Model: DW2000 and DW3000

Serial #: 72 – 111

Product Bulletin # DW-012

DW BHPU Pressure Switch Upgrade

Figure 2: Add snubber between pressure switch and connection adapter as shown

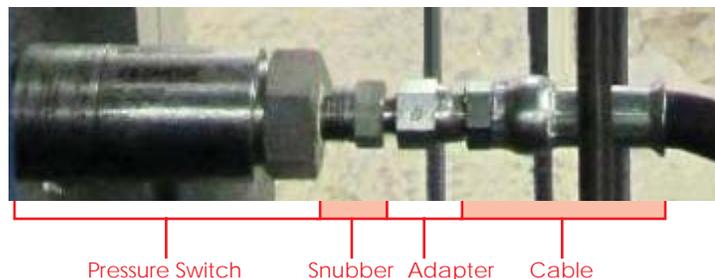
The equipment manufacturer for the Canrig BHPU recommends adding a snubber to the pressure switch connections to improve switch life. This improvement applies to Drawworks 2000 and 3000 BHPUs for serial numbers 72 – 111.

1. Communicate with the rig manager to ensure a good time to make the upgrade.
2. Lock out/Tag out power sources.
3. Install the snubber (Canrig P/N: H14020 - SNUBBER, PRESSURE, 1/4" NPT, SS, DRWKS) between the pressure switch and connection adapter as shown in Figure 2. Torque to 20 ft-lb.
4. Repeat for all four pressure switches.
